SUBJECT: Forwards addl info in response to NRC 820115 request re
 heated junction thermocouple reactor vessel level
 measurement sys. Info responds to Question 2 re axial
 spacing.

Subject: Docket Nos. 50-361 and 50-362
San Onofre Nuclear Generating Station
Units 2 and 3

HJTC Reactor Vessel Level Measurement System San Onofre Units 2 and 3

FIGURE 1
SAN ONOFRE 2&3 REACTOR VESSEL

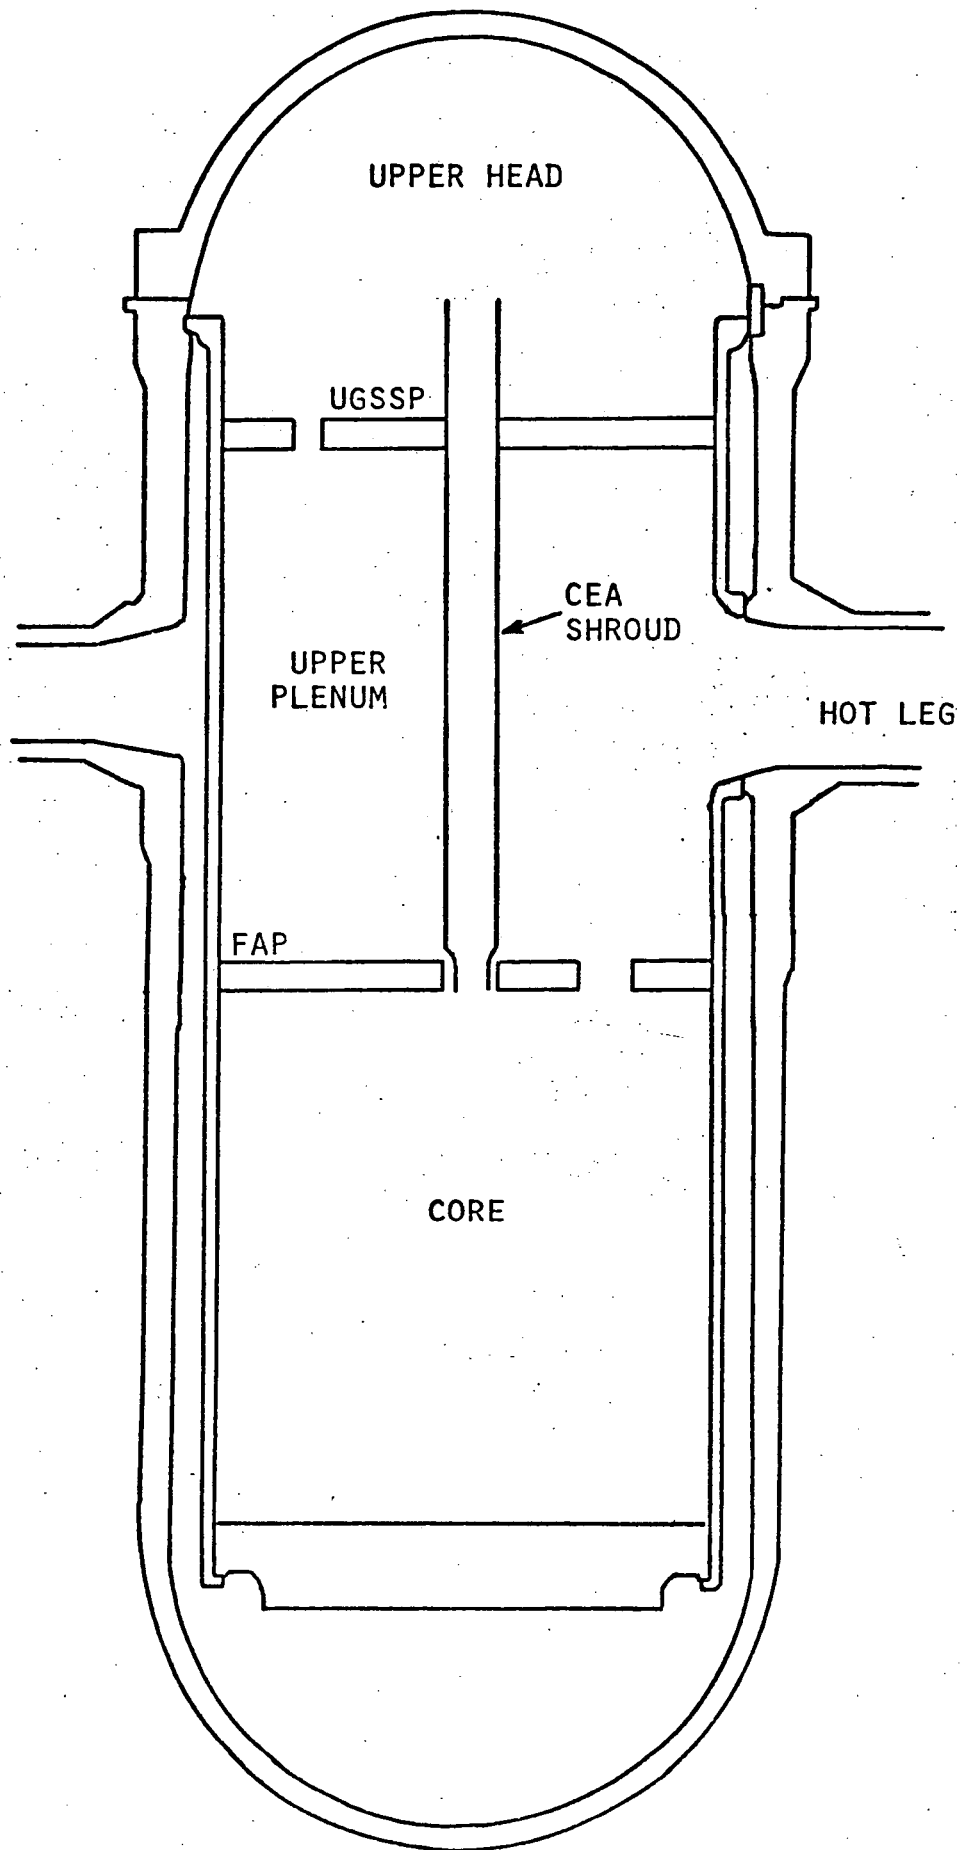
Discuss the axial spacing chosen for the HJTC sensors for Units 2 and 3.

The HJTC System measures the collapsed water level in the reactor vessel above the Fuel Alignment Plate (FAP). The volume above the FAP in the San Onofre Units 2 and 3 reactor vessels can be pictured as being two separate regions (Figure 1). The region between the FAP and Upper Guide Structure Support Plate (UGSSP) is the upper plenum. The second region, between the UGSSP and the top of the vessel head, is the upper head. The HJTC probe assembly is located outside of a CEA shroud and extends through both these regions.
